**SUBDIVISION &  
ZONING AMENDMENT STAFF REPORT****Date: July 21, 2022**

<b><u>APPLICANT NAME</u></b>	Square 1 Plaza
<b><u>SUBDIVISION NAME</u></b>	Square 1 Plaza Subdivision
<b><u>LOCATION</u></b>	915 and 907 Hillcrest Road (East side of Hillcrest Road, at the West terminus of Timbers Drive).
<b><u>CITY COUNCIL DISTRICT</u></b>	Council District 6
<b><u>PRESENT ZONING</u></b>	B-2, Neighborhood Business District
<b><u>PROPOSED ZONING</u></b>	B-3, Community Business District
<b><u>AREA OF PROPERTY</u></b>	3 Lots / 2.5± Acres
<b><u>CONTEMPLATED USE</u></b>	Subdivision Approval to create three legal lots of record from eighteen (18) legal lots of record; and Rezoning from B-2, Neighborhood Business District to B-3, Community Business District. <b>It should be noted, however, that any use permitted in the proposed district would be allowed at this location if the zoning is changed. Furthermore, the Planning Commission may consider zoning classifications other than that sought by the applicant for this property.</b>

# DETAIL SITE PLAN

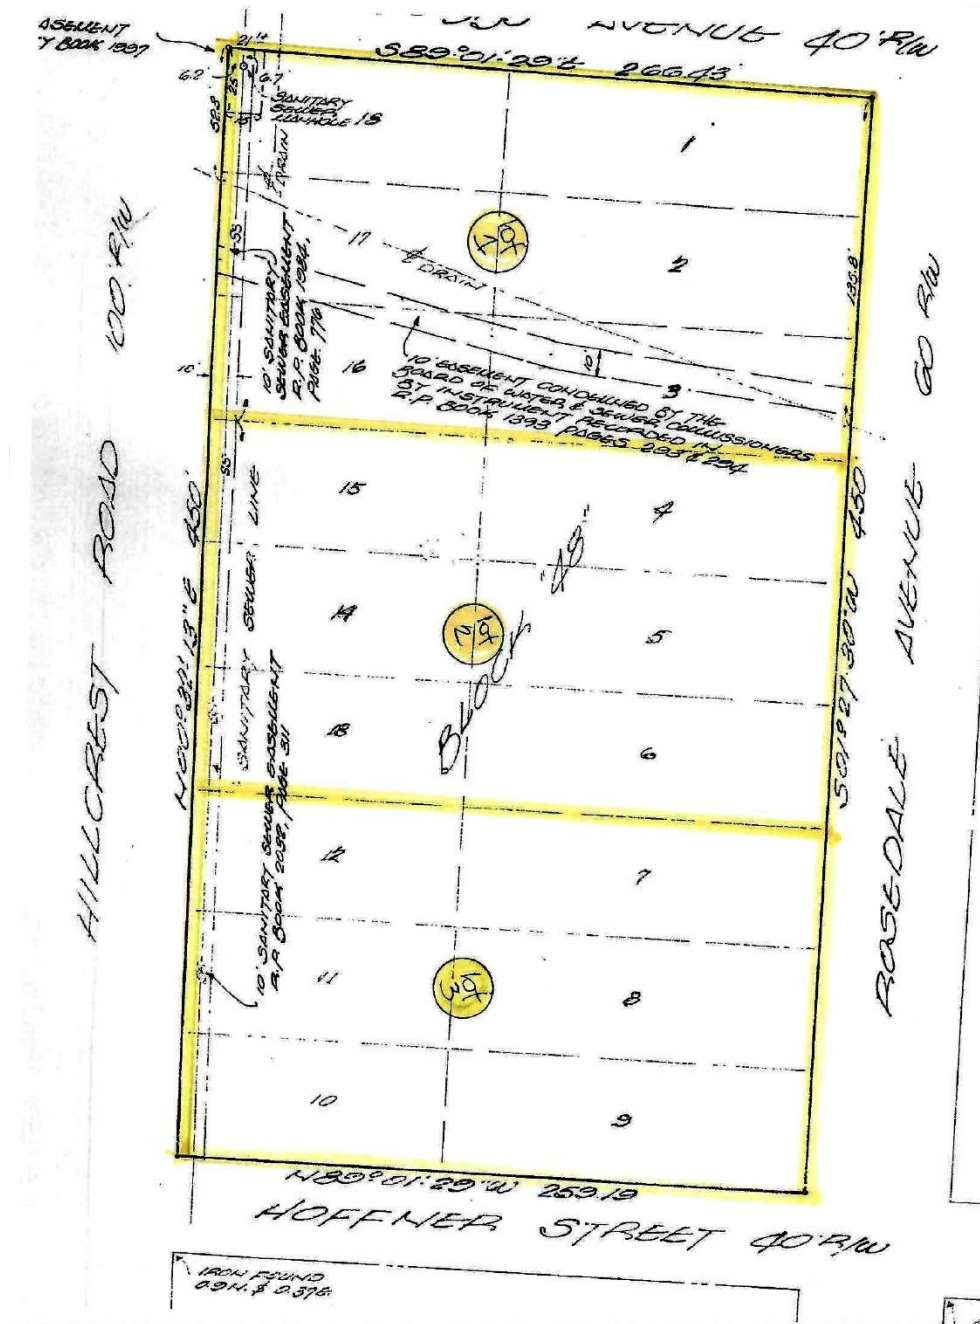
The applicant proposes to create three legal lots of record from eighteen (18) legal lots of record. The applicant submitted a copy of the previously recorded Subdivision plat, with the proposed lot lines depicted. It appears that the proposed lots will each exceed the minimum size requirements of the Subdivision Regulations, as approved.

There are two sanitary sewer easements depicted on the plat, which should be depicted on the Final Plat, if approved, as well as a note stating that no structures are allowed in any easement without the approval of the easement holder.

The 25' minimum required setback is not depicted along any of the street frontages, and if approved, should be shown along all street frontages.

The site plan submitted depicts the existing structure and parking lot. No new development is proposed at this time. The site currently exists with shared parking and access across multiple lots, and the functionality of the property will not change; however, Planned Unit Development (PUD) approval will be required if physical changes are proposed to the site.

- 1) provision of a Final Plat as required by Section IV.C.2. of the Subdivision Regulations;
- 2) provision of the lot size in square feet and acres, or the provision of a chart depicting the same information;

- 3) depiction of the 25' minimum building setback along all rights-of-way;
- 4) placement of a note on the Final Plat stating that no structures are allowed in any easements, without the approval of the easement holder;
